Service Bulletin

Bulletin No.: 19-NA-183

Subject: Mandatory VECI Label Replacement for (5W7) Performance Air Intake Kits

1. VECI Label placement for Trucks

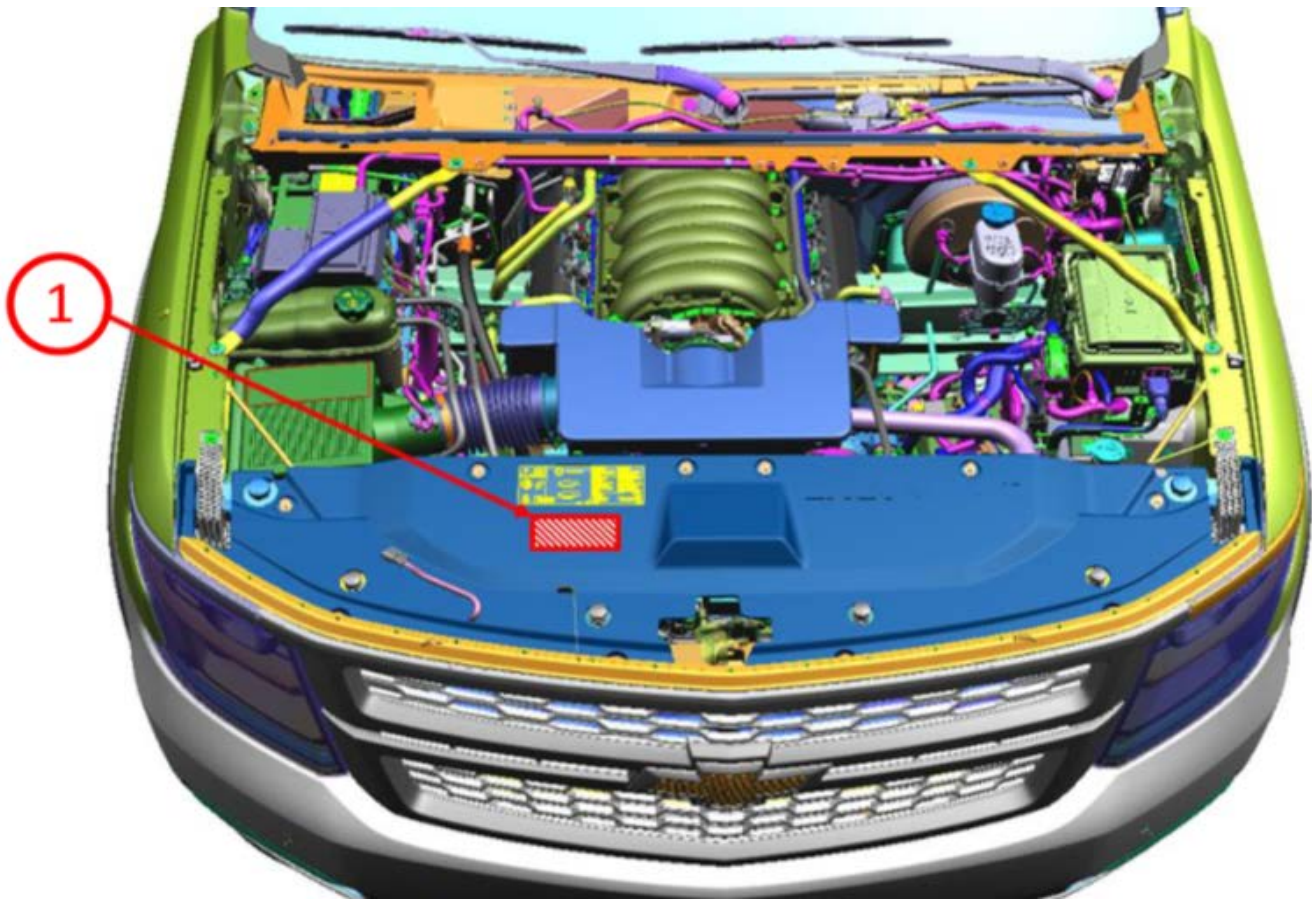
2. Dealer Piece Cost for the label will be billed to the BARS/Open Account monthly. Dealer Statement will include the Part Number Reference and Dealer Piece Cost.
3. The Dealer cost of the label (\$20.12 USD) and 0.2 hr allowable labor time is to be charged to labor OP code 0602798. The transaction type is ZREG.
4. Label will ship from the supplier in 1-2 business days.
5. Installation of Label - Clean the application surface so that there is no dust, oil, or other contaminants that will affect the label adhesion.
6. The label should be applied to the locations shown in the photos below to ensure that the label is visible in the engine compartment for emissions inspection purposes.

1. Order service part number 19354745 for a replacement VECI label.
